June 26, 2014
NRC-14-0052

Subject: Response to NRC Request for Additional Information Regarding the Fermi 2 Flood Hazard Reevaluation Report (TAC No. MF1101)

**Enclosure to
NRC-14-0052**

**DTE Response to NRC Request for Additional Information
Regarding the
Fermi 2 Flood Hazard Reevaluation Report**

Figure 1. Cross section B with estimated onsite ground surface elevations with identification labels.

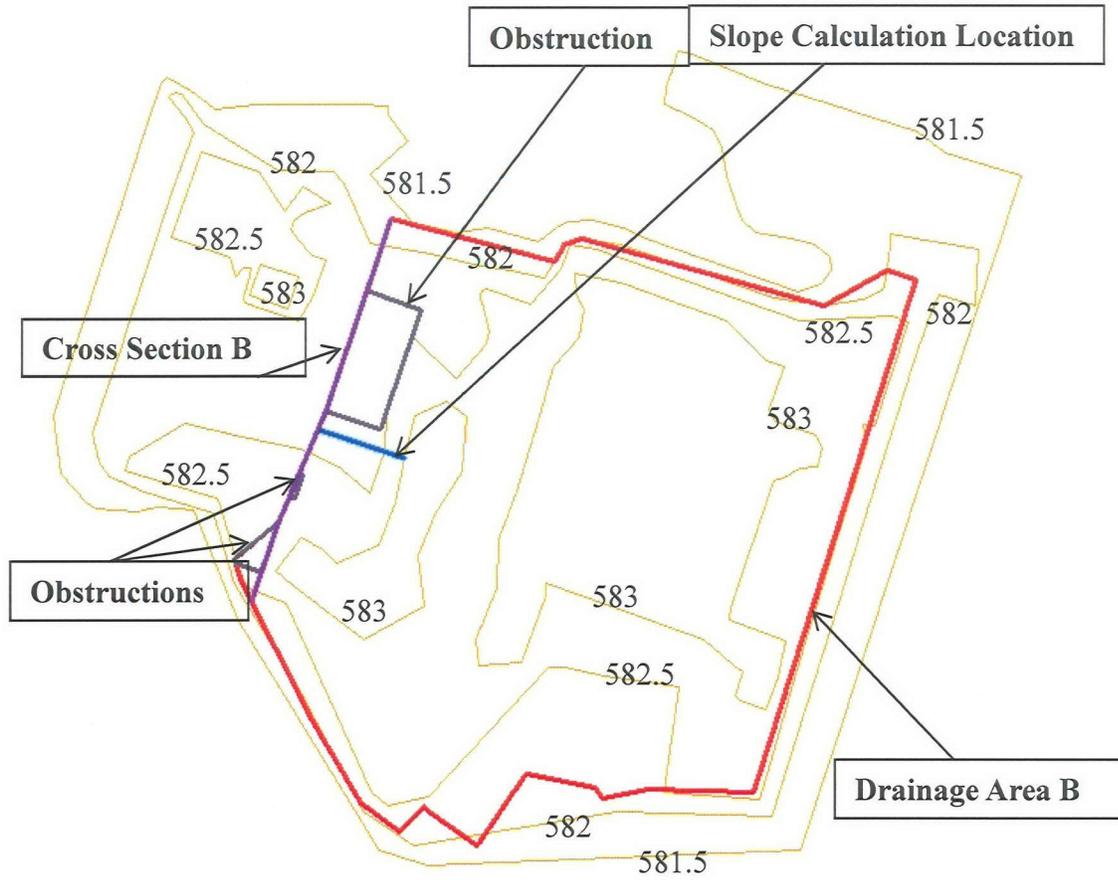
- a) Provide a basis to explain how the base elevation (582 ft.) along cross section B was selected. If an average base elevation along cross section B is greater than 582 ft., provide an updated estimate for the maximum water surface elevation. Also provide the supporting onsite ground surface elevation in native electronic format, if available.
- b) Discuss the basis for the acceptance criterion of 583.5 ft. for the LIP analysis.

- a) Within Calculation 177910.51.1001, cross section B was given a constant bottom elevation of 582.0 ft Plant Datum (PD) as this is approximately the onsite ground surface elevation, (contour lines), associated with the drainage area boundary located to the east of cross section B. It was conservatively assumed for this cross section that the entire drainage area to the east will flow to the west through this cross section. As shown on Figure 1, there are some elevations along the cross section that are below 582.0 ft PD and some areas that are above 582.0 ft PD. Because there are some higher elevations than 582.0 ft PD on cross section B, it was decided to also compute the runoff depth for cross section C in the Location C drainage area. This cross section C took into account a cross section bottom elevation of 582.5 ft PD. By using a higher channel bottom elevation for cross section C, the drainage area to cross section C will be smaller. The smaller drainage area associated with cross section C was the portion that would drain past the RHR Complex building passing through the higher 582.5 ft PD channel bottom elevation. The smaller drainage area for cross section C is shown on Figure 2. The smaller drainage area for cross section C produced a lower water surface elevation (583.02 ft PD) than cross section B (583.4 ft PD).

Therefore, to maximize the drainage area that was conservatively assumed to drain to the west, passing through cross section B, the cross section's channel bottom elevation was set to the approximate drainage area boundary's onsite ground surface elevation contributing to that cross section, which is 582.0 ft PD. If cross section B were to have a higher channel bottom elevation, then a smaller drainage area would contribute to that cross section with a higher channel bottom elevation, as described above for cross section C.

In conclusion, for Calculation 177910.51.1001 the base elevation chosen for cross section B is 582.0 ft PD. This elevation conservatively maximizes the flow through the cross-section and results in a higher water surface elevation than if a greater base elevation were used.
